Subject: Docket No. 50-329/330
Midland Plant - Units 1 and 2
Overview of the Construction
Completion Program
Serial No. SWMCP-021

Re: FCR/FCN Review (Electrical)

STONE AND WEBSTER ENGINEERING CORPORATION
NONCONFORMANCE IDENTIFICATION REPORT

DATE OF NONCONFORMANCE: 1-25-84 NIR NUMBER 013

NIR 013
ATTACHMENT 2
SHEET 2 of 2

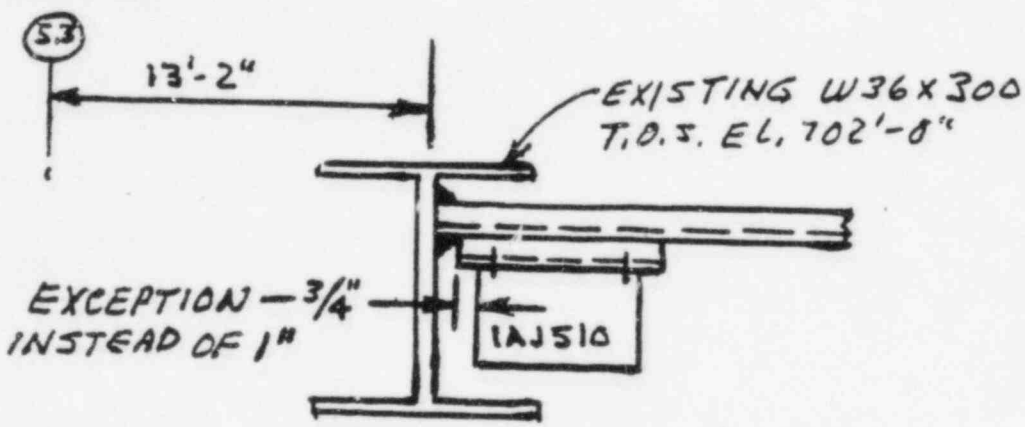
- 1) FCN E-997 Sheet No. of affected drawing in Block "C" is missing (Attachment 1).
- 2) FCN E-1052 & E-1657 Block "A" addressed one drawing. Resolution Sheet addresses more than one drawing (Attachments 2 & 3).
- 3) FCN E-1647 & E-2003 Block "A" was left blank (Attachments 4 & 5).
- 4) FCN E-1951 Corrections were made on Resolution Sheet without MPQAD's concurrence (Attachment 6).
- 5) FCN E-7689 Block "A" plus Block "B" did not equal Block "C" (Attachment 7).
- 6) FCN E-8810 Reviewed By Block on Resolution Sheet was left blank (Attachment 8).

PROBLEM: DOCUMENTS WERE INDICATED IN THE PRIMARY DWG OR "SPEC" BOX OR THE "OTHER DWGS OR SPEC'S AFFECTED" BOX AND WERE INDICATED BY PROJECT ENGINEERING AS NOT REQUIRING INCORPORATION OR REVISION

POTENTIAL IMPACT STATEMENT (YES NO) NO POTENTIAL FOR MISINSTALLATION EXISTS. THE FCN WAS ATTACHED TO MORE DWG(S) THAN REQUIRED PER THE REMARKS SECTION. THE FCN WAS FOR A UNIQUE INSTALLATION ONLY AS IDENTIFIED IN THE BODY OF THE FCN

REMOVE FCN FROM THE FOLLOWING DRAWING DISTRIBUTION LIST E-92(W)

FCN HAS BEEN RETIRED FROM E-92(W) REF. FCN This is a one time deviation

REMARKS: NO DRAWING INCORPORATION REQUIRED
[Signature] 9-13-79

NIR 013
ATTACHMENT 3
SHEET 2 of 2

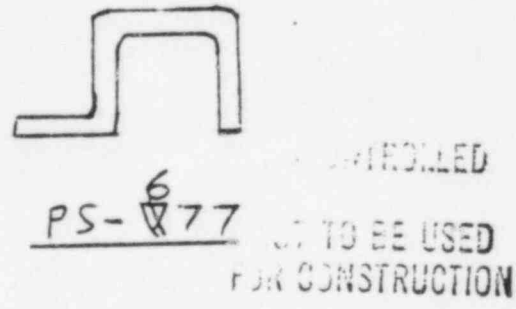
PROBLEM: DOCUMENTS WERE INDICATED IN THE PRIMARY DWG OR "SPEC" BOX OR THE "OTHER DWGS OR SPEC'S AFFECTED" BOX AND WERE INDICATED BY PROJECT ENGINEERING AS NOT REQUIRING INCORPORATION OR REVISION

POTENTIAL IMPACT STATEMENT (YES/NO) (YES) NO POTENTIAL FOR MISINSTALLATION EXISTS. THE FCN WAS ATTACHED TO MORE DWG(S) THAN REQUIRED PER THE REMARKS SECTION. THE FCN WAS FOR A UNIQUE INSTALLATION ONLY AS IDENTIFIED IN THE BODY OF THE FCN

REMOVE FCN FROM THE FOLLOWING DRAWING DISTRIBUTION LIST

E-644(D)

* CLARIFICATION ONLY - THIS IS A ONE TIME DEVIATION

REMARKS
CHANGE APPROVED - NO DRWG REVISION REQUIRED
180 1-3-80
J.A.A. 1-4-80
